CAPITAL BUDGET PROJECT #1132 & #1186
Collins Mechanical H-01 CHANGE ORDER

CHANGE ORDER
City of Saratoga Springs

No. H-01
[Signature]

LAKE AVE FIREHOUSE

Dwg Number:	Ref. Dwg:	Revision:
PR	RADIATOR	H-101
H-001	RECONDITIONING	
	LOCATION PLAN	
	LAKE AVE FIREHOUSE	
APN: H-001	Date: 04-19-12	Drn by: DAR

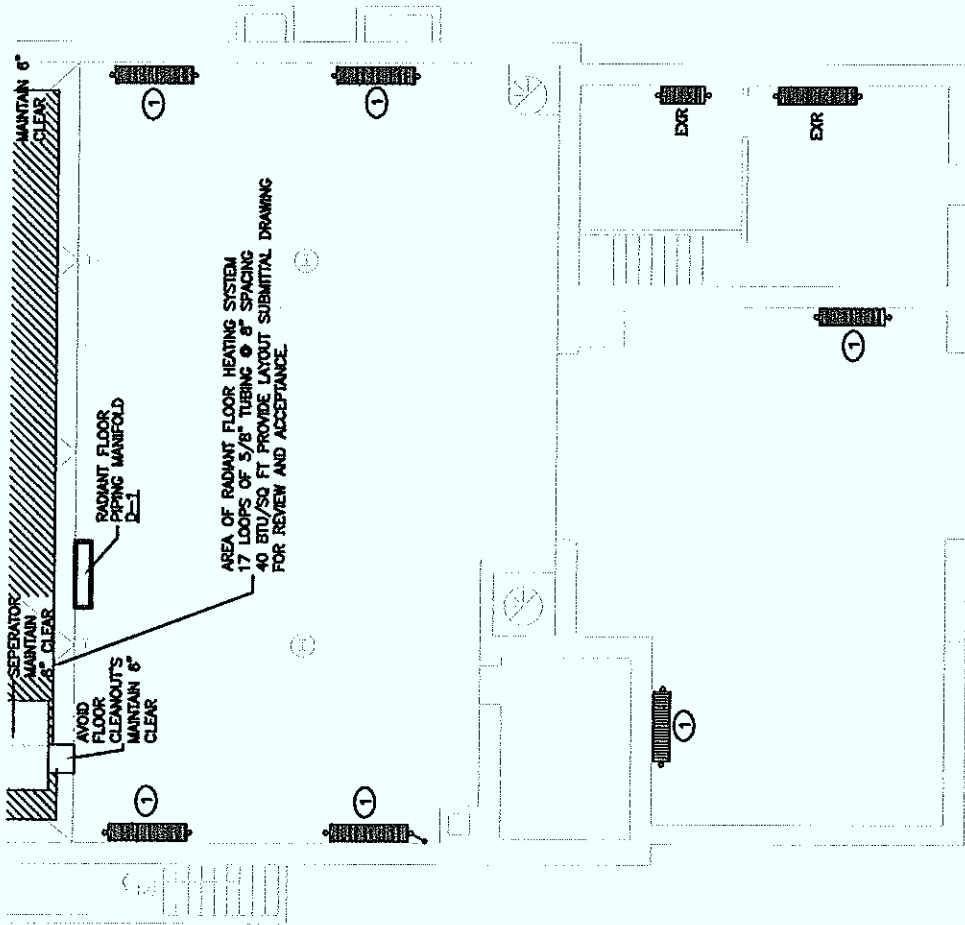
- 1) Please provide a separate **COST** proposal with an itemized breakdown for labor and materials for **each** of the following items:
 - a) Remove the existing (disconnected) radiator and associated piping on the first floor level.
 - b) Remove, recondition & re install the existing radiators in the shop areas per Sketches PR H-001 & PR-H-002

① REMOVE RADIATOR TO ALLOW FOR NEW FLOOR WORK TO BE PERFORMED. REFER TO SKETCH PR-H002 FOR WORK REQUIRED AT EACH RADIATOR.

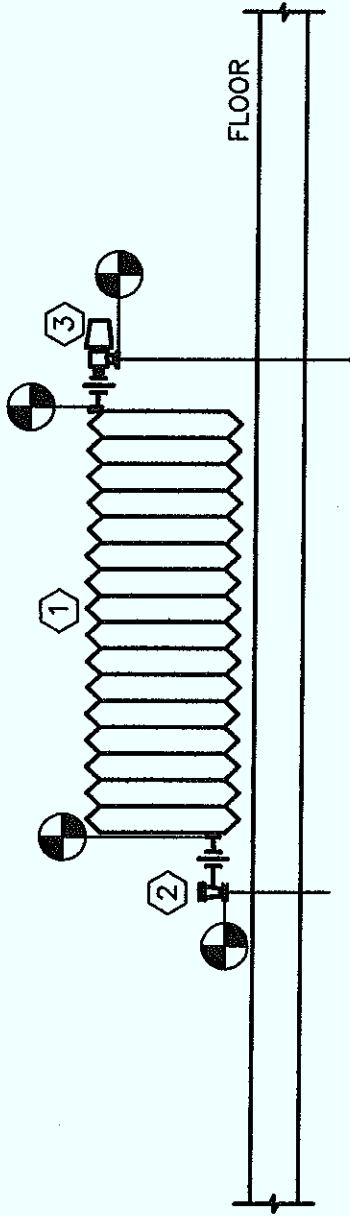
- ① REMOVE RADIATOR TO ALLOW FOR NEW FLOOR WORK TO BE COMPLETED. STRIP EXTERIOR OF RADIATOR AND PAINT. FLUSH INTERIOR OF RADIATOR TO REMOVE SEDIMENT ETC.... RE-INSTALL RADIATOR AFTER CONCRETE FLOOR WORK IS COMPLETED.
- ② REMOVE EXISTING STEAM TRAP FROM CONDENSATE LINE. PROVIDE NEW STEAM TRAP SPRAX-SARCO RTA-125 AND RECONNECT TO EXISTING PIPING AND RADIATOR AT UNION.
- ③ REMOVE CONTROL VALVE FROM STEAM SUPPLY. PROVIDE NEW DANFOSS STEAM CONTROL VALVE RA-2000 SERIES ANGLE PATTERN WITH INTERNAL SENSOR AND RECONNECT TO EXISTING PIPING AT UNION.
